DRAINAGE LETTER REPORT

For
BENT GRASS COMMERCIAL

Bent Grass Market View
El Paso County, Colorado

PCD File No: **PPR2625**

Pipe ID: **24" RCP (DP-1 & DP-2)**

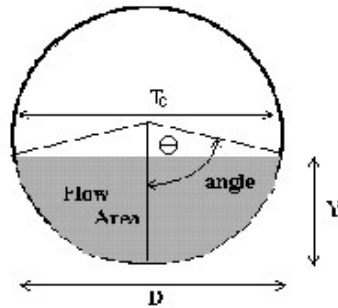
Provide calculations for the existing forebay to determine if the capacity and forebay notch are appropriate with the additional flows.

Provide calculations that verify that drain times will comply with state senate bill 15-212, CRS 37-92-602(8)

BENT GRASS EAST
COMMERCIAL FILING NO. 3
DEVELOPED DRAINAGE MAP

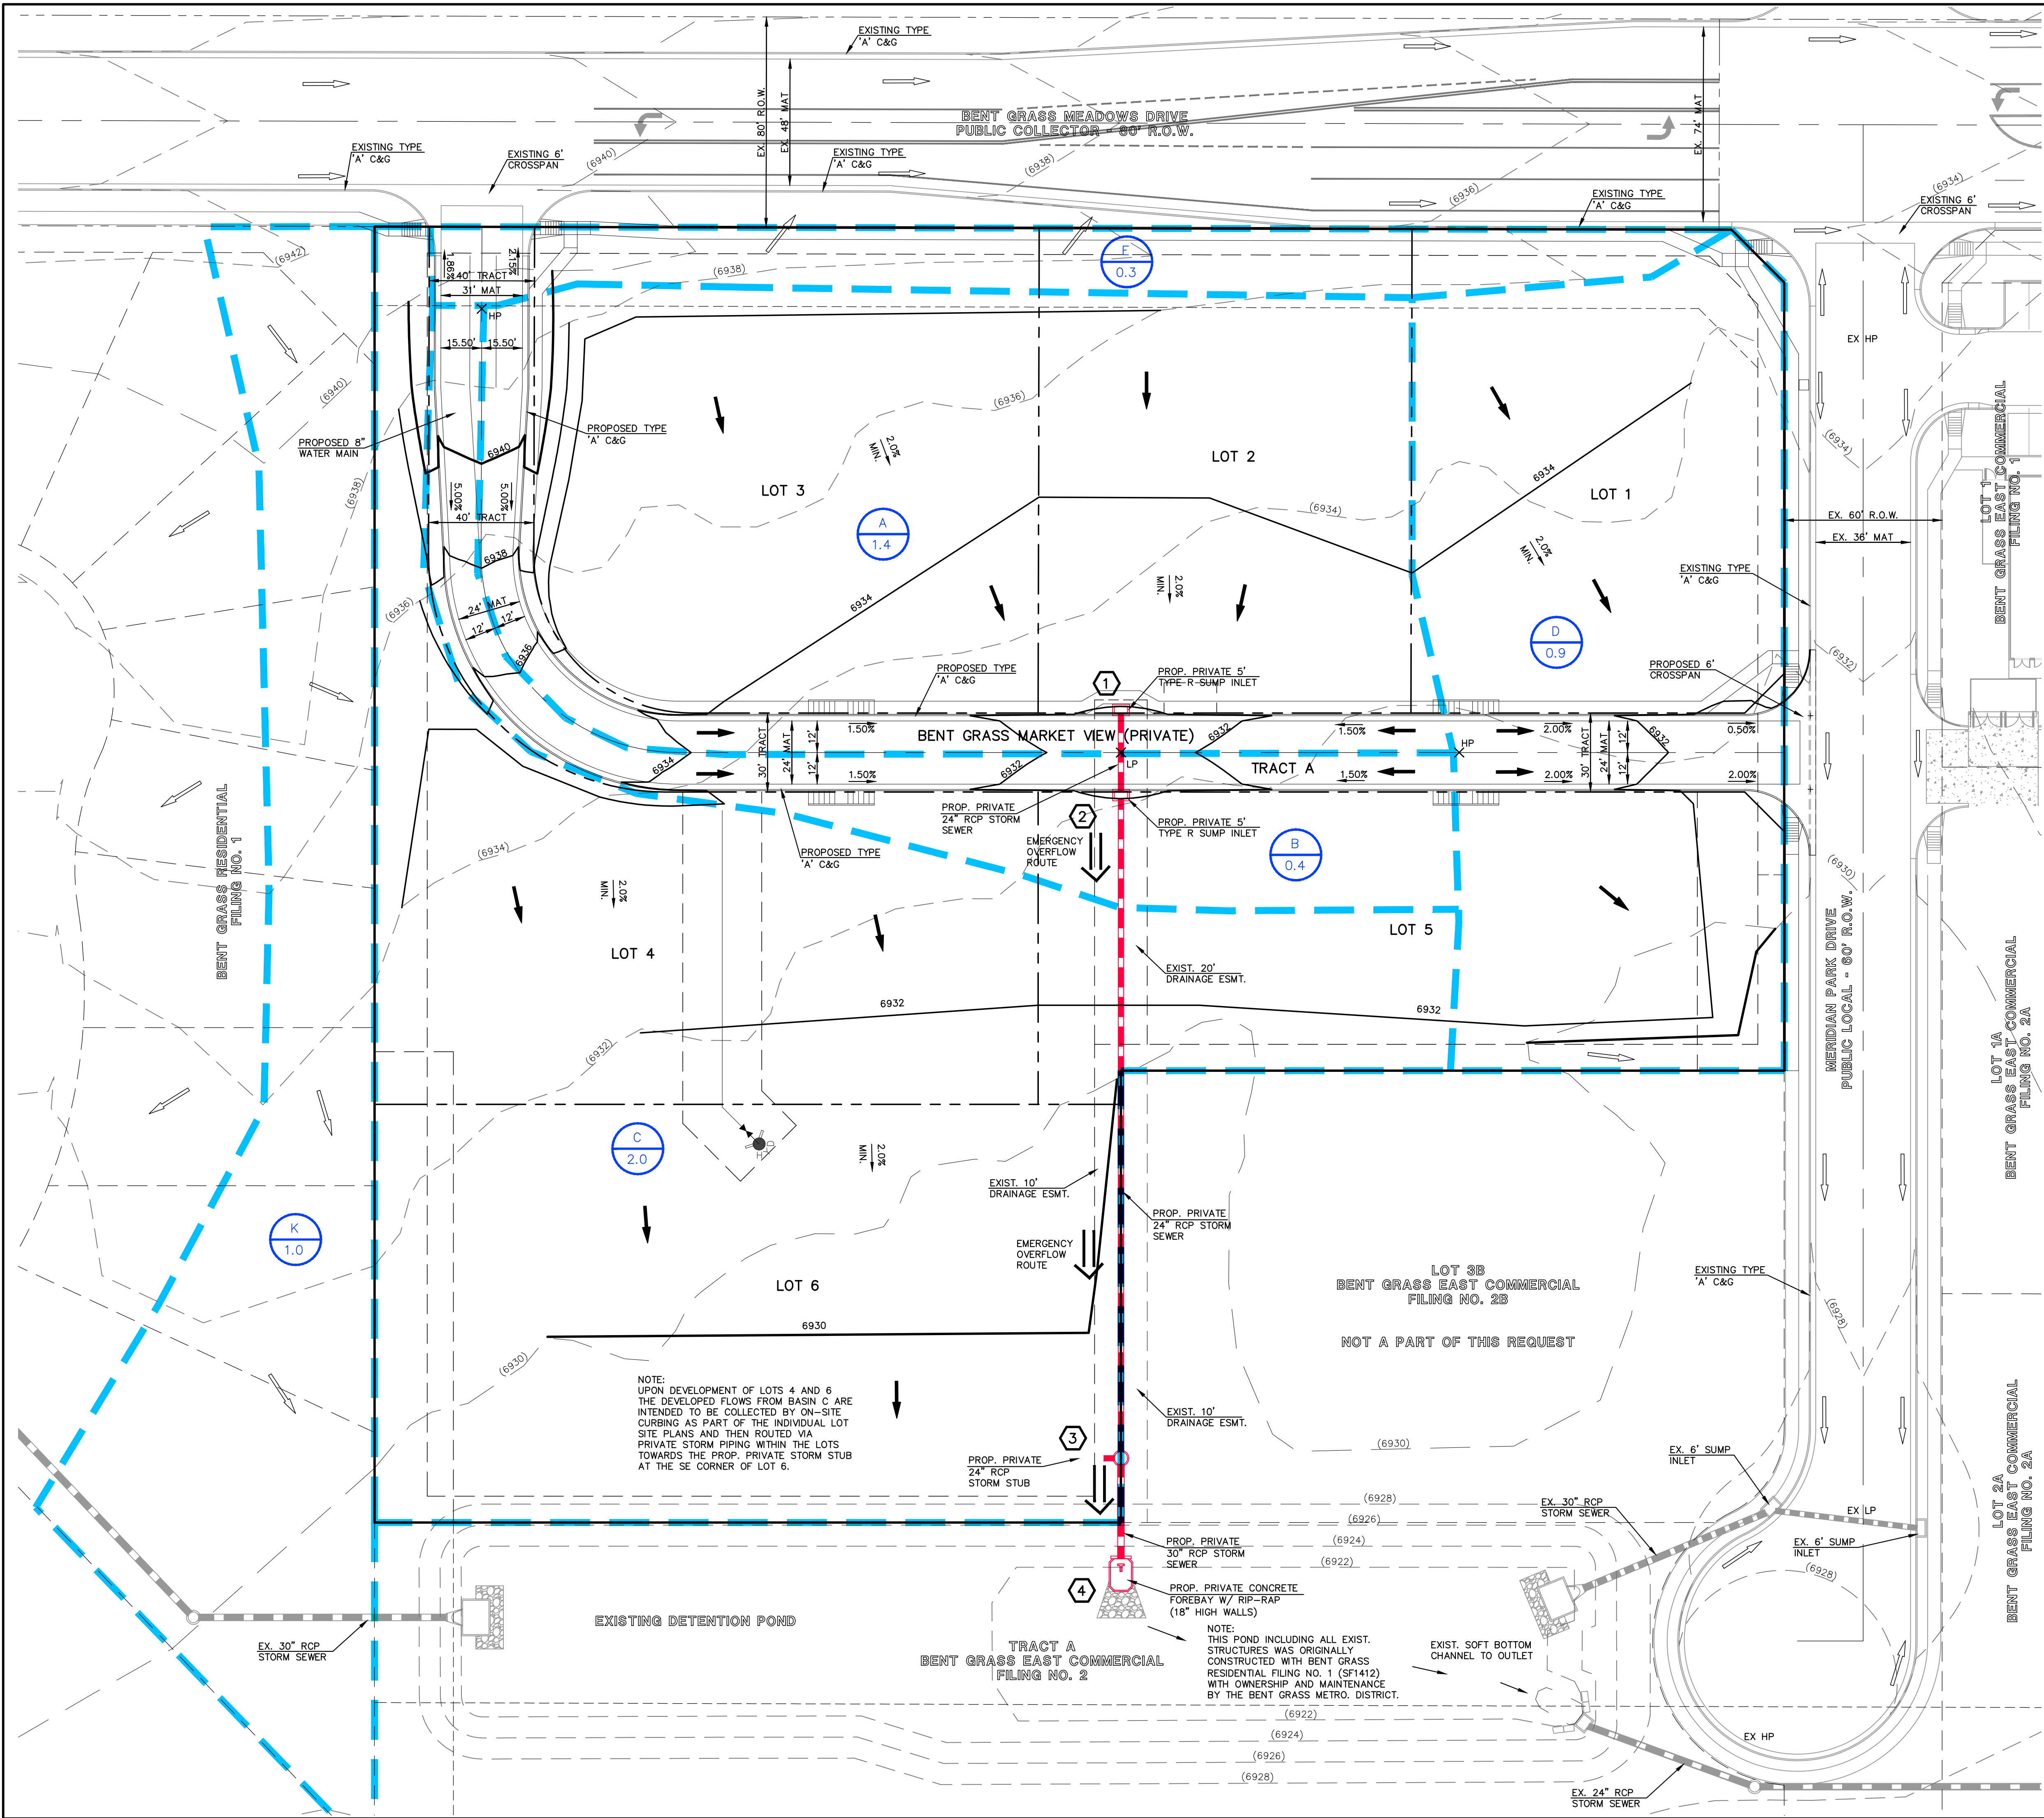
Label these sheets as reference material from a previous report (and provide PCD file number) or provide difference appendix sections for reference material and your calculations

Ensure reference sheets are clearly labeled throughout report. It's difficult to track when they are mixed together, and it can be confusing when basin IDs/DPs aren't shared.
